Reference: Water Rights Application: G-17990

Purpose: Protest of Proposed Final Order, and request contested case hearing

Protestor: Philip Hammack - HAMAK Corporation
1516 NW 5th Street, Bend, OR 97703
(541) 385-6728

PLATE 1

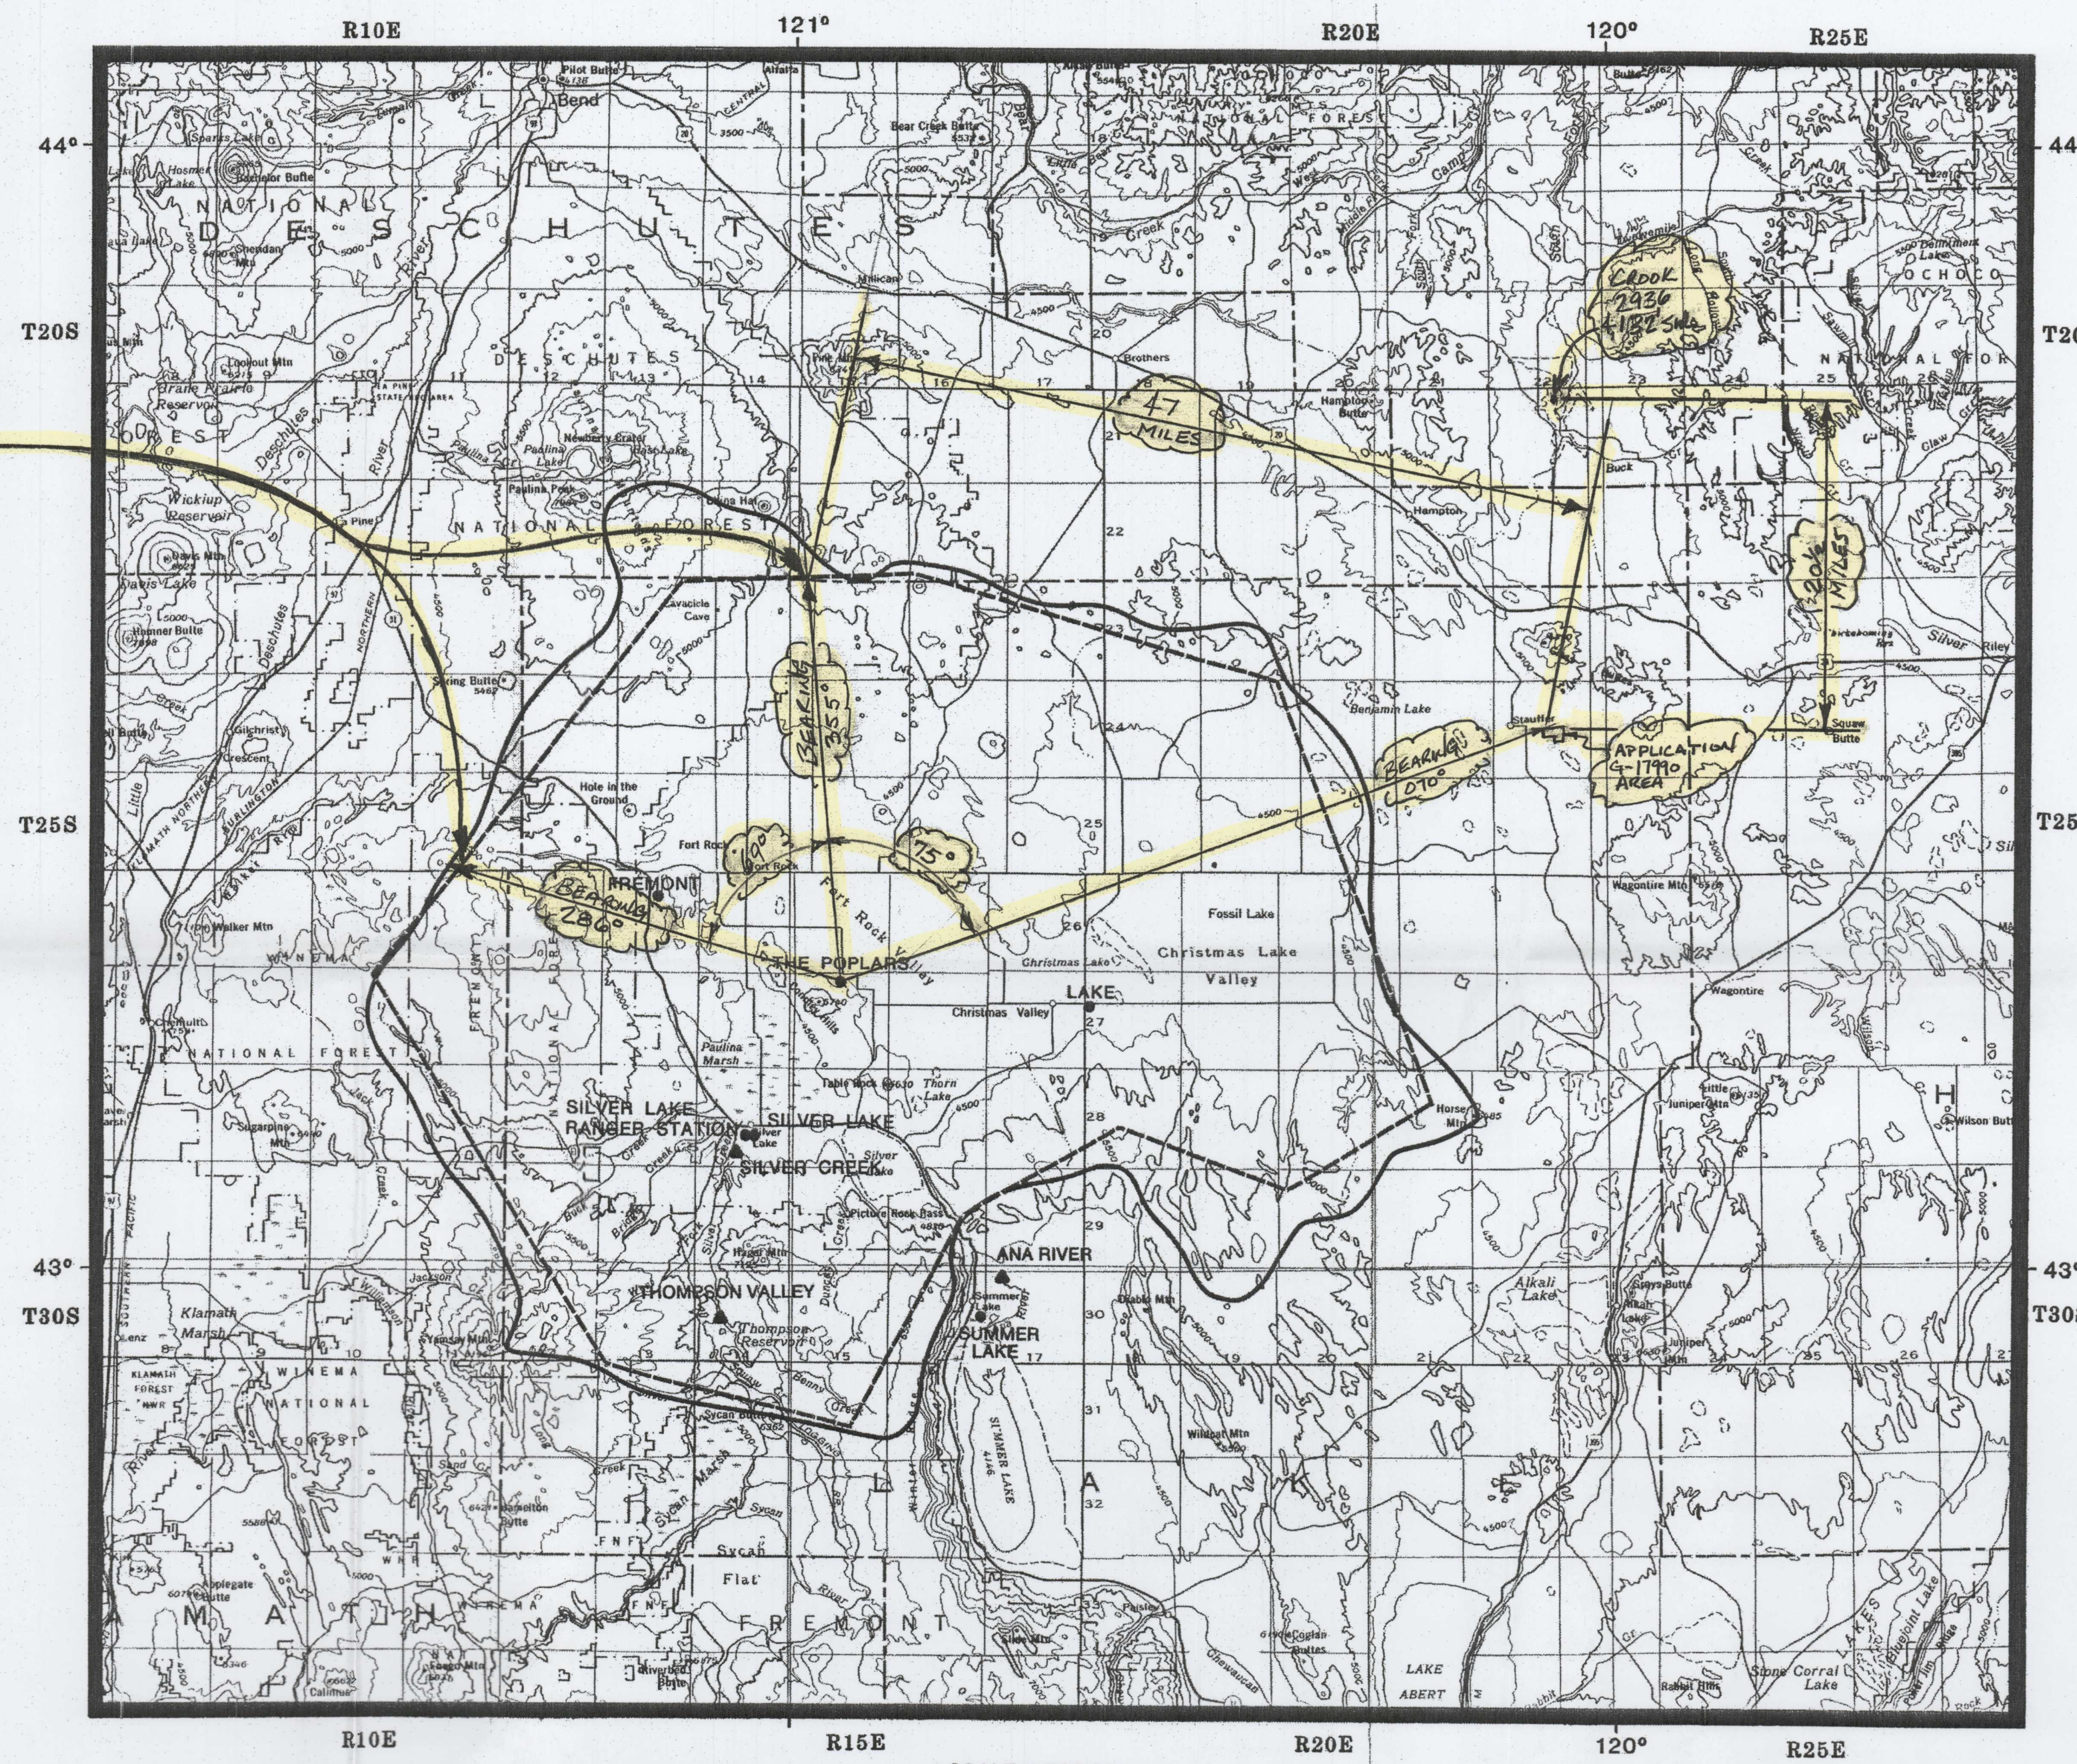
Miller 1986 clearly identifies that the Fort Rock-Christmas Valley Groundwater Limited Area discharge outflow to the Deschutes Basin occurs from the northwest portion of the Limited Area across a 30 mile arc. With the radius point centered in the Limited Area, application G-17990's area is 75 degrees east of the nearest part of the discharge outflow path flowing to the Deschutes Basin with a respective 47 mile separation.

Therefore per Miller 1986, application G-17990 is **not** "part of ... down-gradient groundwater outflow to the Deschutes Basin from the Fort Rock Groundwater Limited Area".

30 MILE WIDE
SUBSURFACE
GROUNDWATER
DISCHARGE TO
THE DESCHUTES
BASIN
